Albuquerque, NM
Academy
Building Addition
SITE PLAN

THIS DRAINAGE PLAN SHALL SUPERCEDE THE APPROVED DRAINAGE PLAN FOR THIS SITE, ENGINEER'S STAMP DATE 06-08-01, PREPARED BY CHAVEZ AND GRIEVES CONSULTING ENGINEER'S INC. DRAINAGE FILE D-19-D4A. MINOR MODIFICATIONS HAVE BEEN MADE TO THE AFOREMENTIONED DRAINAGE PLAN NECESSITATING THIS SUBMITTAL. THE SITE, CURRENTLY UNDER CONSTRUCTION, HAS BEEN AND WILL CONTINUE TO BE CONSTRUCTED PER THE ORIGINAL PLANS WITH THE EXCEPTION OF MODIFICATIONS TO THE PREVIOUSLY PROPOSED STORM DRAIN INLET, PUMP DISCHARGE LINE, AND DRY WELL.

CHANGE ORDER
BUILDING ADDITION
ISSUE #4
CASE# 0158284
DATE: 10-31-02

HYDROLOGY SECTION
DRAINAGE PLAN
AND CALCULATIONSQwest
Manager - Real Estate EngineeringQwest
Business Resources - Real Estate
Albuquerque, New Mexico
5A202-AC-SKC07

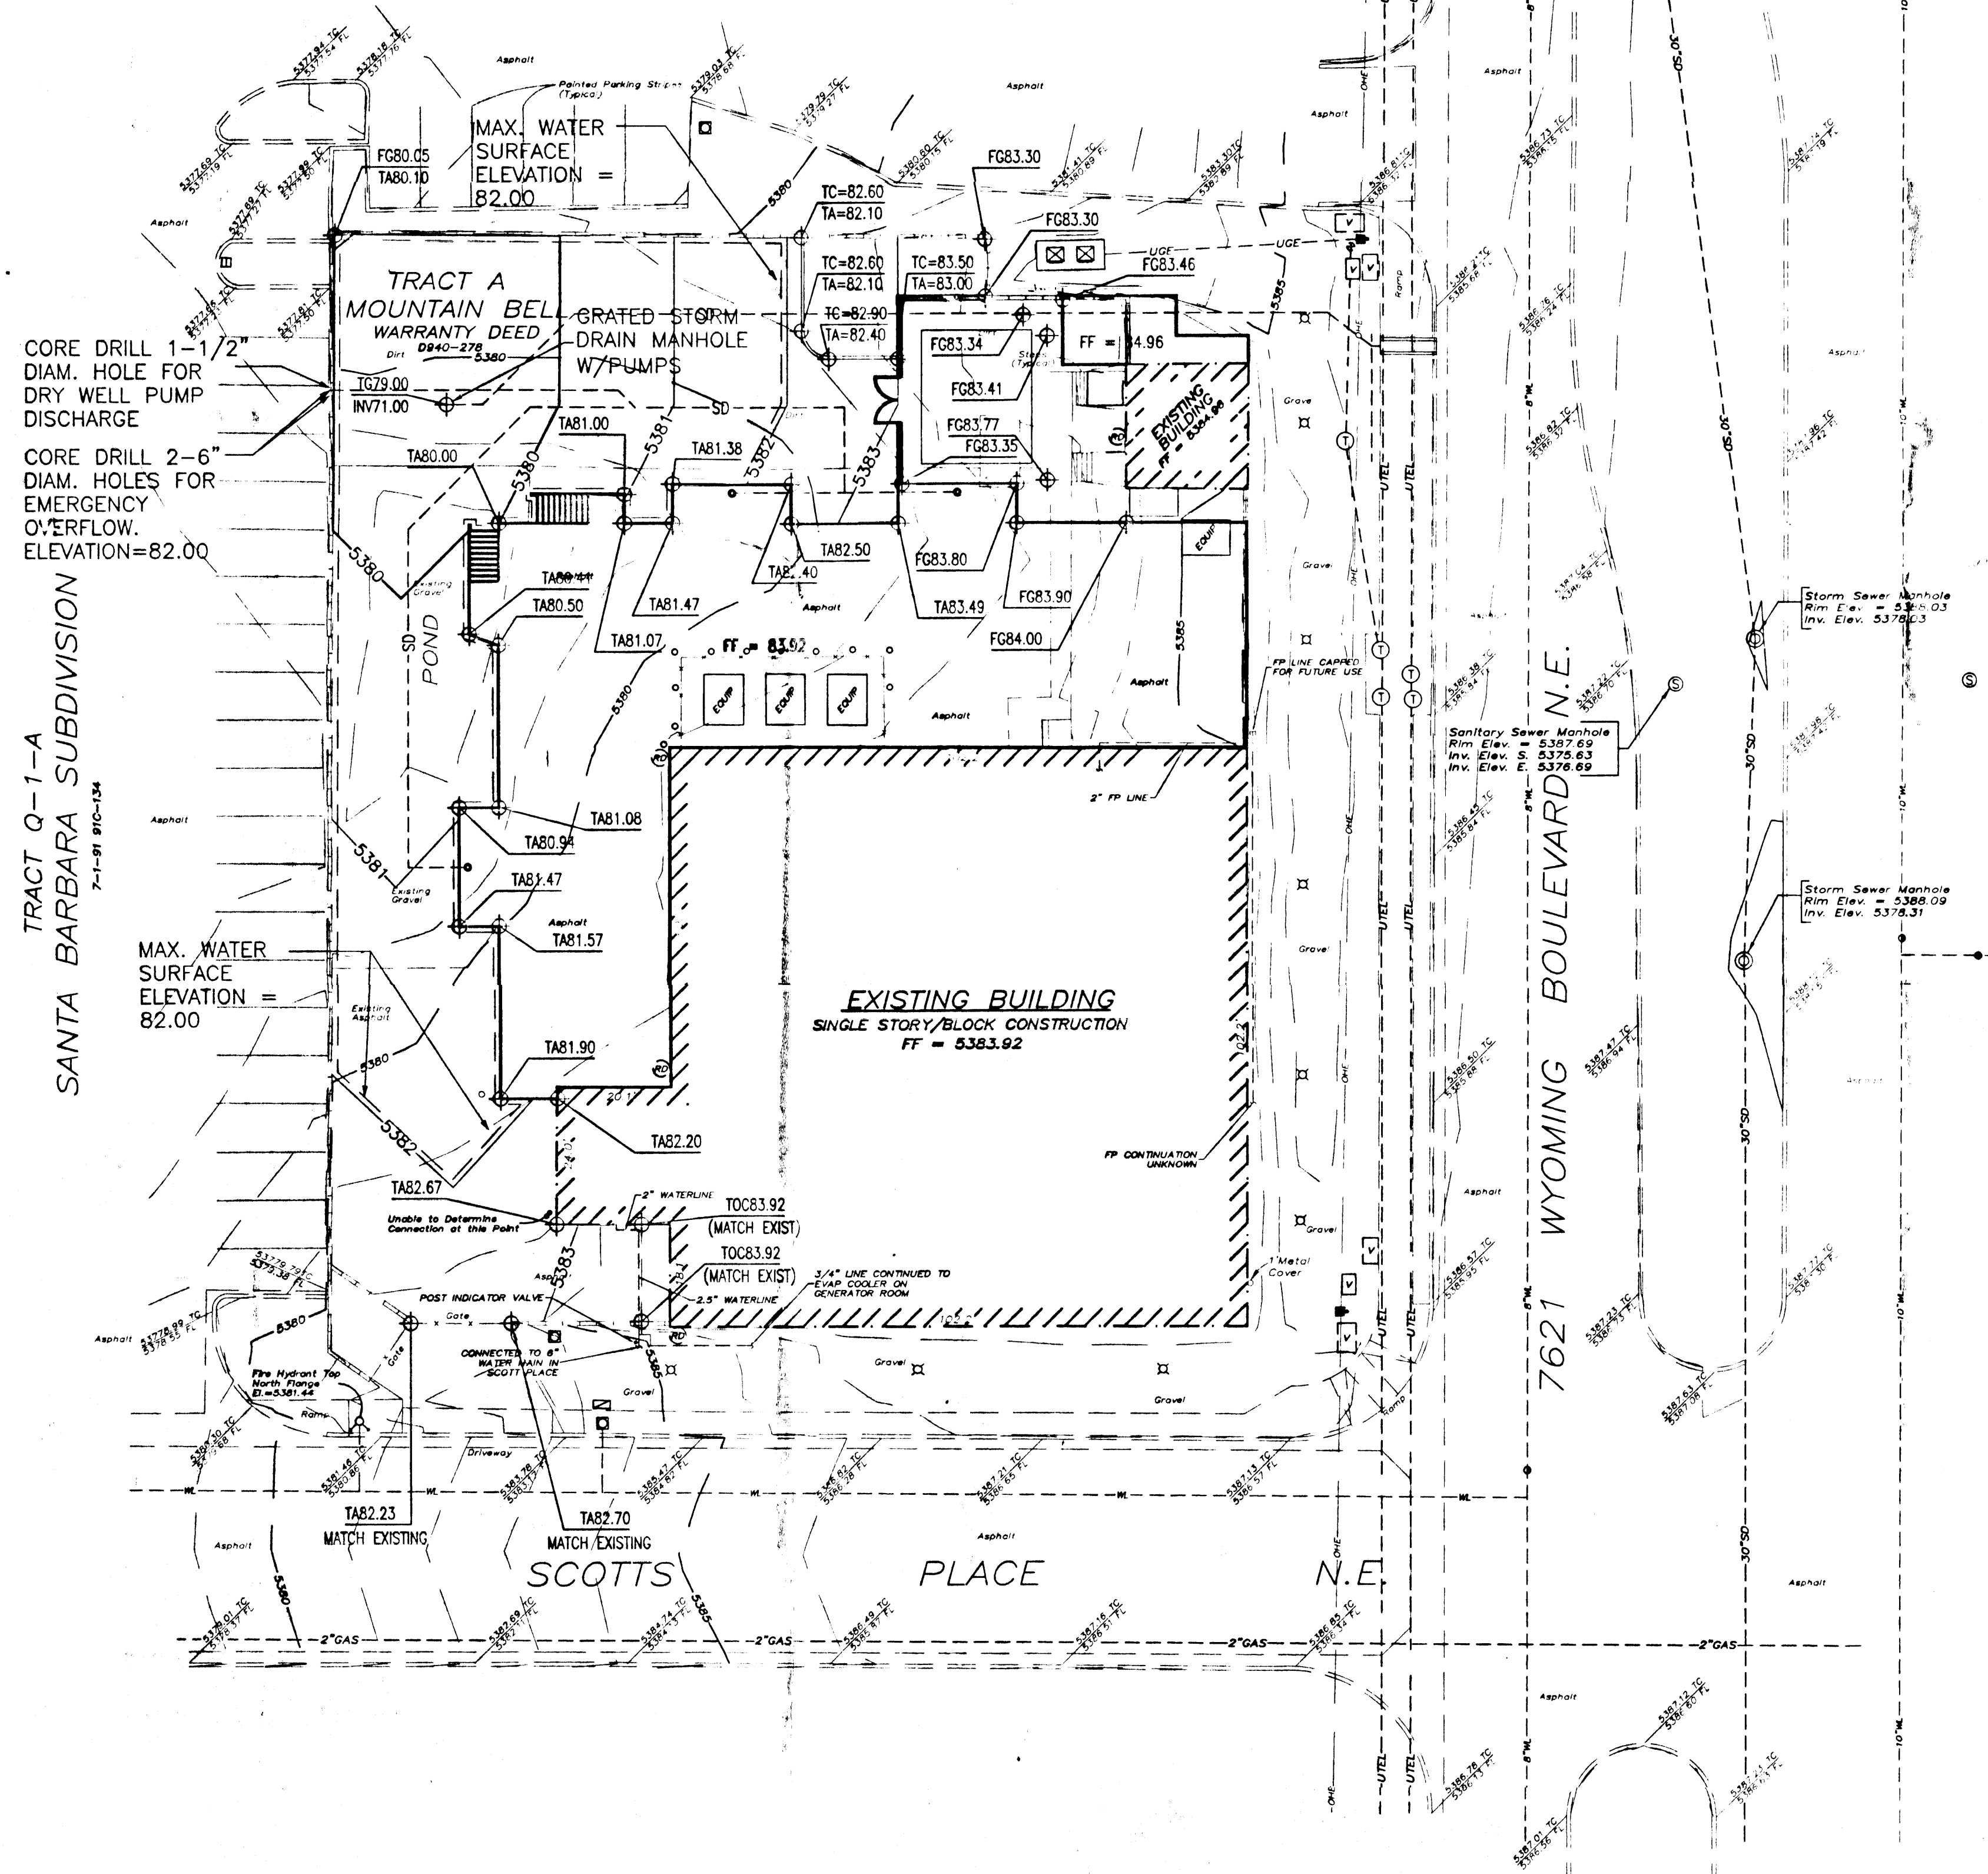
- 19 EXISTING 2" FLOOR DRAIN.
- 20 MODIFY EXISTING STORM DRAIN MANHOLE CONSTRUCTED PER DETAIL 8/SHEET C06 (ORIGINAL APPROVED 05-09-01 PLAN SET). INSTALL NEENAH R-1755 WATERTIGHT FRAME SOLID LID AND INNER LID OR APPROVED ALTERNATE. INSTALL HYDRAULIC BV-A1 SUBMERSIBLE SUMP PUMP OR APPROVED ALTERNATE AT BOTTOM OF MANHOLE. PUMP TO BE CAPABLE OF DISCHARGING 5gpm @ 20 FT OF HEAD. INSTALL 1" CONDUIT FOR POWER SOURCE TO BUILDING AND 1-1/2" PVC DISCHARGE LINE TO WEST WALL AS SHOWN.

- 30 1-1/2" PVC C-900 DRY WELL PUMP DISCHARGE LINE.
- 31 CORE DRILL HOLE IN WALL FOR 1-1/2" DISCHARGE LINE AT GRADE.
